# ANN ARBOR BUILDING BOARD OF APPEALS

## STAFF REPORT

**Type of Request: APPEAL**

Building Board of Appeals Request **BBA22-2000** at 322 E. Liberty, Unit: 13, ANN ARBOR, MI 48104.

1. STAIR SECTION

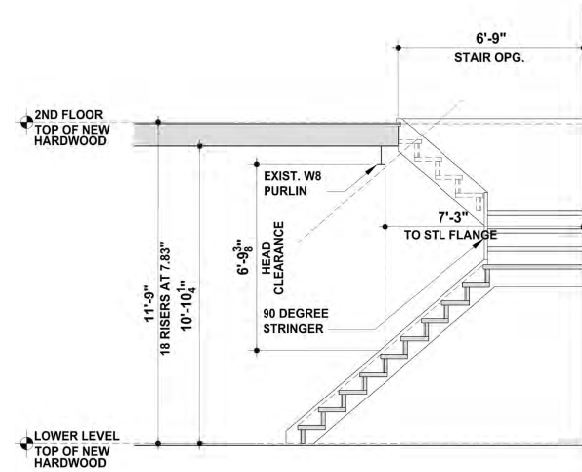
Staff recommends this application be denied as it does not meet the standards for approval, the code has not been misinterpreted, the provisions of the code do apply and the reduction in stairway Geometry is less safe than that required by the governing code (2015 Michigan Building Code).

Per section 1011.5.2 of the 2015 Michigan Building Code the minimum stairway rise and tread depth states stair riser height cannot exceed seven inches, and tread depth shall be eleven inches minimum exception 3 of section 1011.5.2 allows an increase in riser height and reduction in tread depth from the previously mentioned dimensions allowing for seven and three quarter maximum rise and minimum tread depth of ten inches (never is the 2015 Michigan Residential Code referenced).

The construction documents show a replacement stair configuration for the existing spiral stairs. This details for the stair configuration include a riser of 7.83" (8.25" MAX) and 9" Tread.

2ND FLOOR "AS-BUILT" STAIR

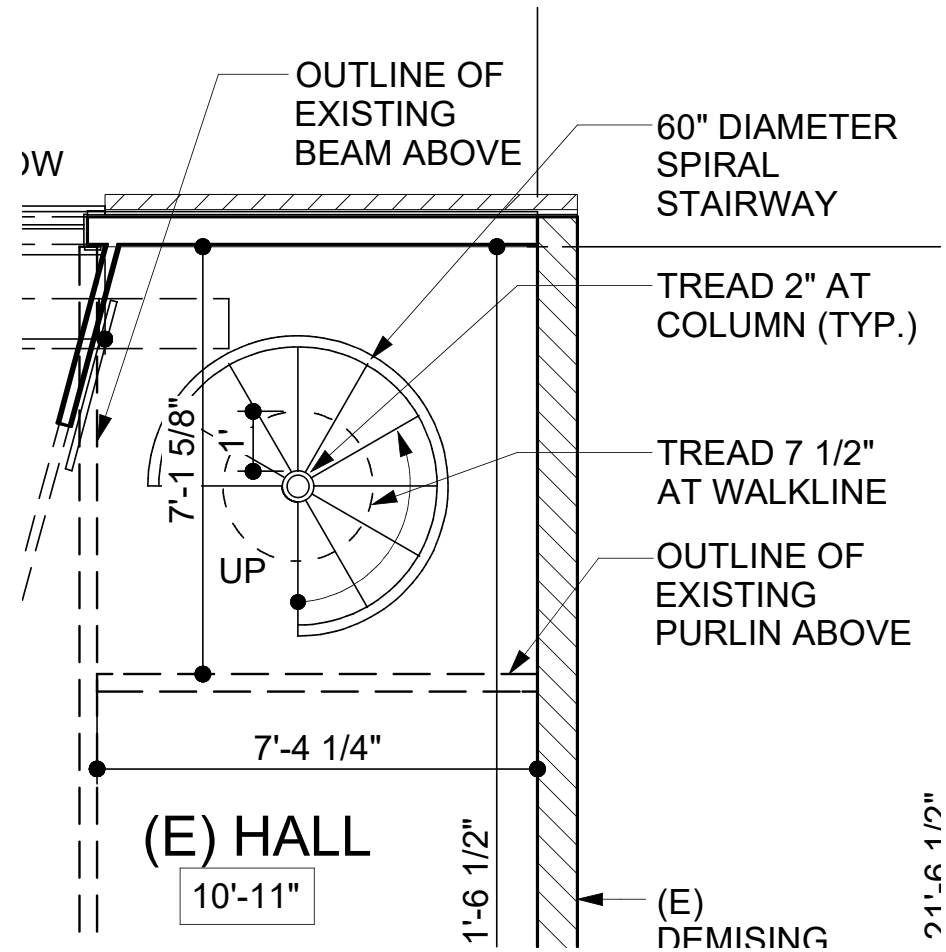
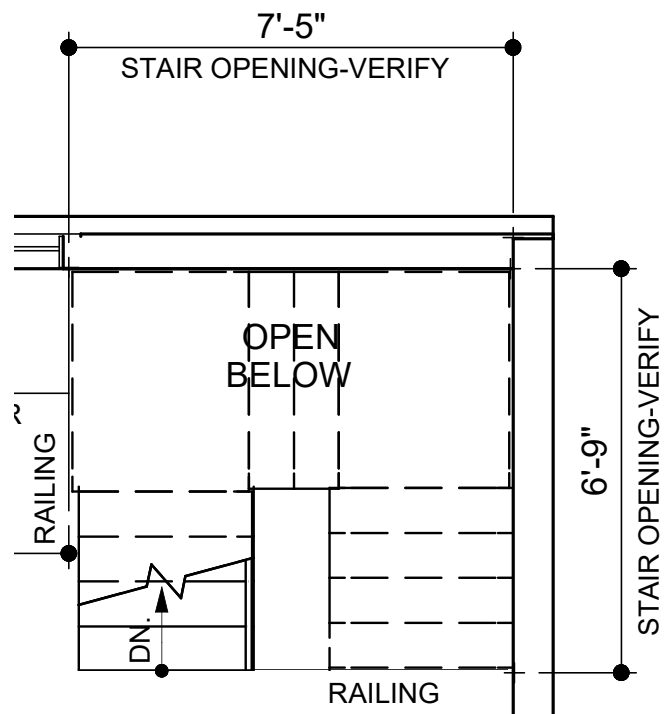
At the onset of this project, the owner was concerned about the safety factor of using the prior "As-built" Spiral Stair on a daily basis. He was concerned about the overall diameter and the extremely shallow treads, and the subsequent risk for slipping that it created for him and his guests. The diameter was VERY narrow (60" total with only 24 1/2" from the inside of the pole) and only 2" tread depth at the inward support column.

Information provided by the owner indicated the existing spiral stairway posed a safety concern as the stairway's . . . "overall diameter and the extremely shallow treads and the subsequent risk for slipping that it created for him and his guest. The diameter was VERY narrow (60" total with only 24 ½" from the inside of the pole and only 2" tread depth at the inward support column."

PERMIT STAIR SECTION

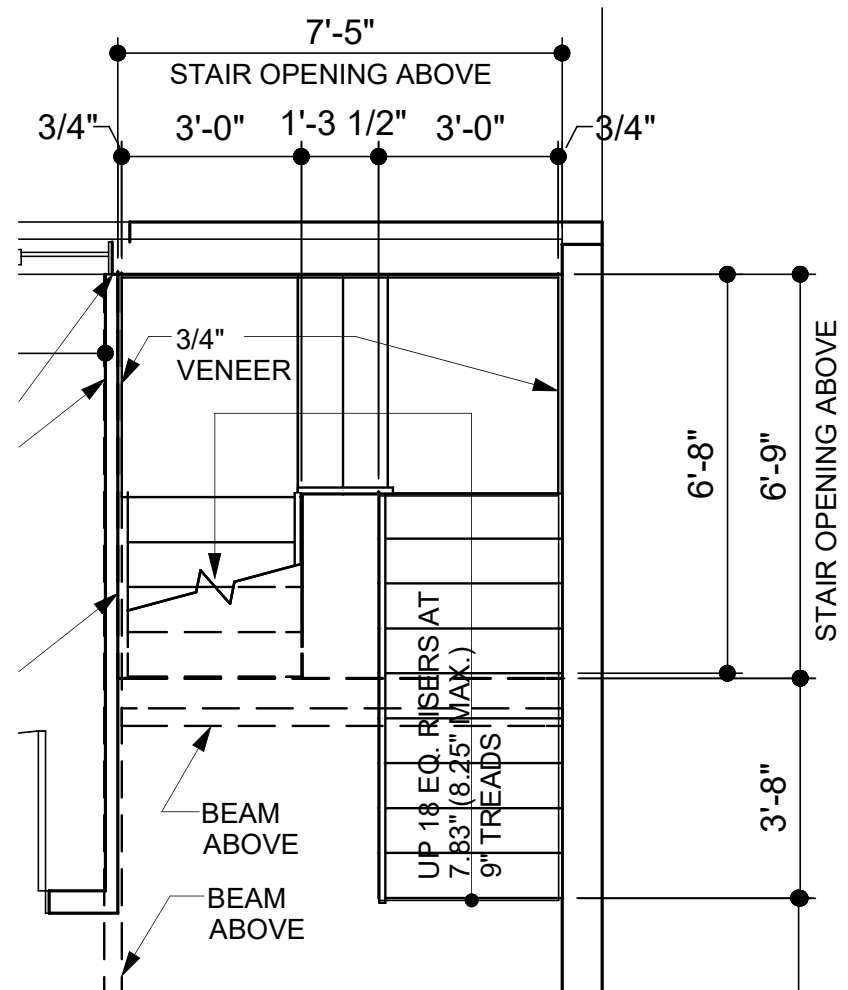
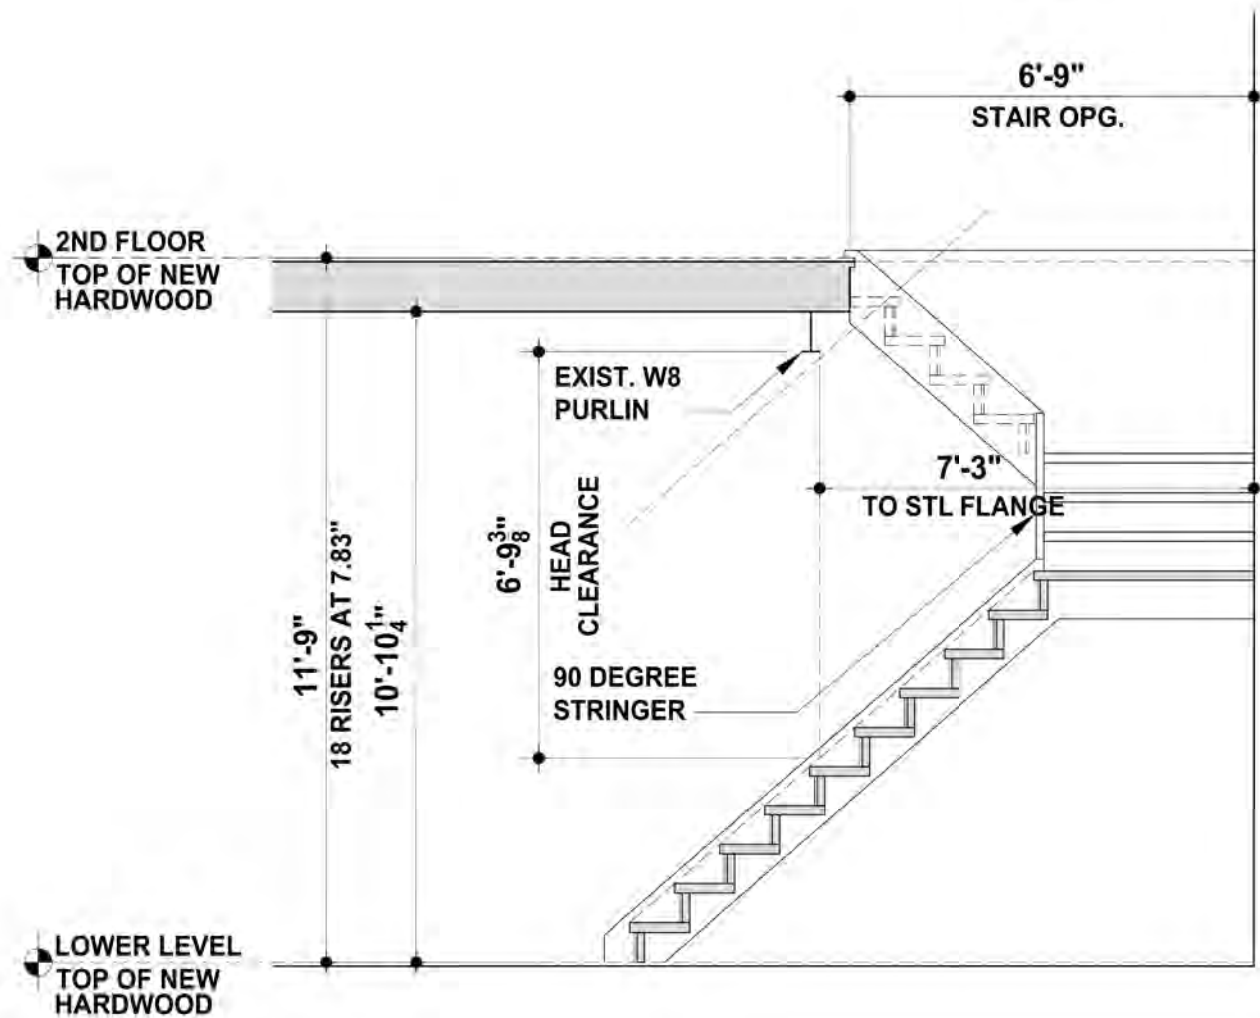
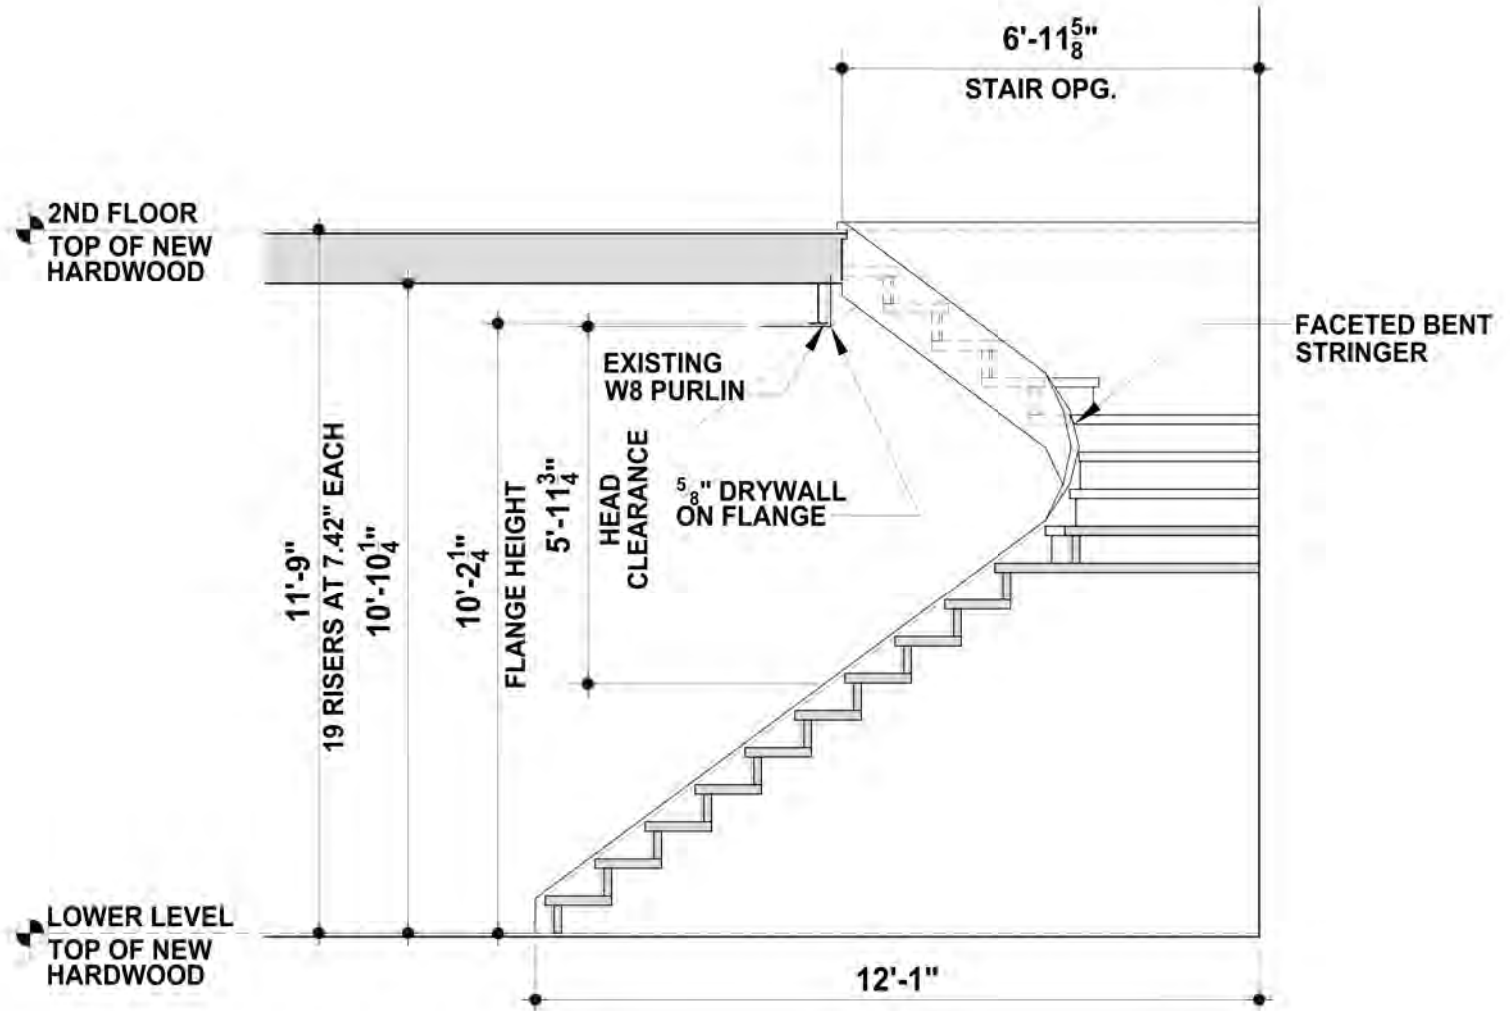
The stair that was designed, submitted, and approved for Permit was the most efficient stairway shape possible for that opening without winders or a spiral configuration (owner requested). The riser and run for

qualified under the 2015 Michigan Residential Code (the risers are within  $\sim 1/16''$  +/- of 2015 MBC compliance) and given it would be owned and operated as a single-family residence, it made sense.
